Safety Recall: 26V337
May 2026

IMPORTANT SAFETY RECALL

Product Safety Notice

Models Included 2025 - 2026 Paradigm 5th Wheels.

Fig. 1

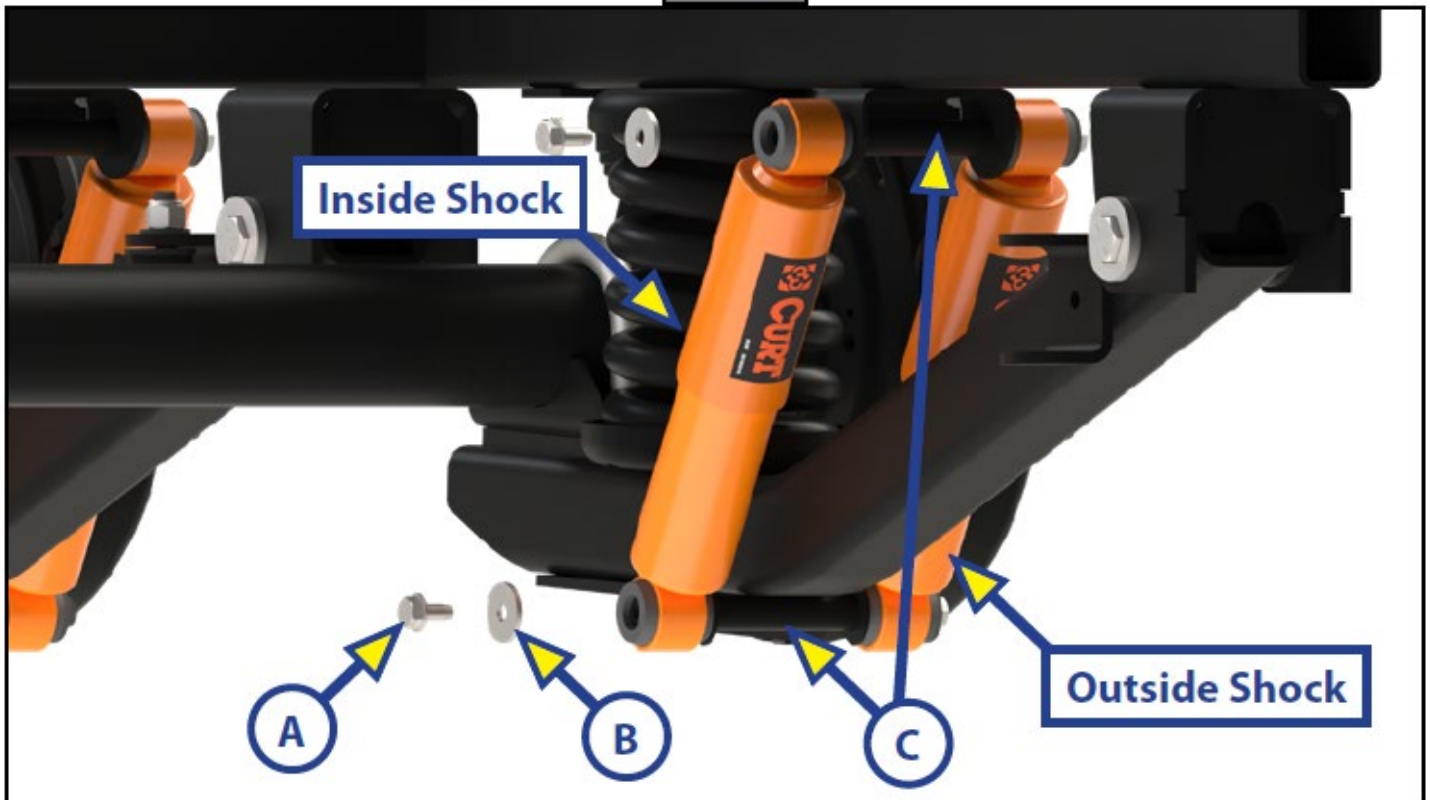
1. Starting with the inside shocks, loosen and remove the two existing 3/8"-16 x 3/4" thread forming screws (Fig. 1A) and washers (Fig. 1B) securing each shock absorber onto its posts (Fig. 1C). Retain washers (PN 249853) for reinstallation in Step 2.

2. Reinstall previously-removed washers onto two new 3/8" - 16 x 3/4" Grade 8 hex head bolts.

Fig. 2

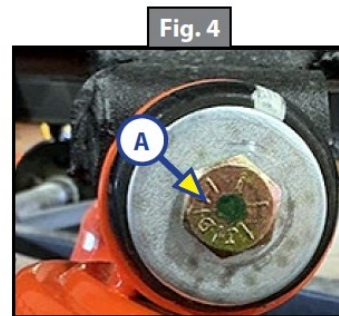
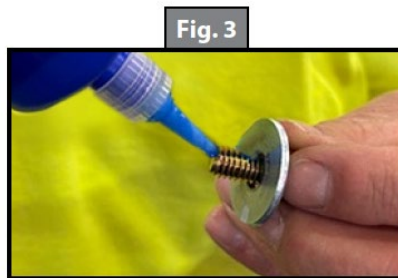
NOTE: Some kits will come with bolts pre-coated with thread locker instead of 0.02oz capsules of Loctite. If the bolts are pre-coated (Fig.2), skip step 3.

3. Apply two threads of thread locker to the Grade 8 bolt threads (Fig 2).
4. Install new bolt assemblies by hand for a minimum of three full threads (or three turns) before proceeding to step 5.
5. Torque new Grade 8 bolts to 20-30 ft-lbs. Do not over torque bolts.
6. Repeat procedure on all other inside and outside shock absorber bolts.
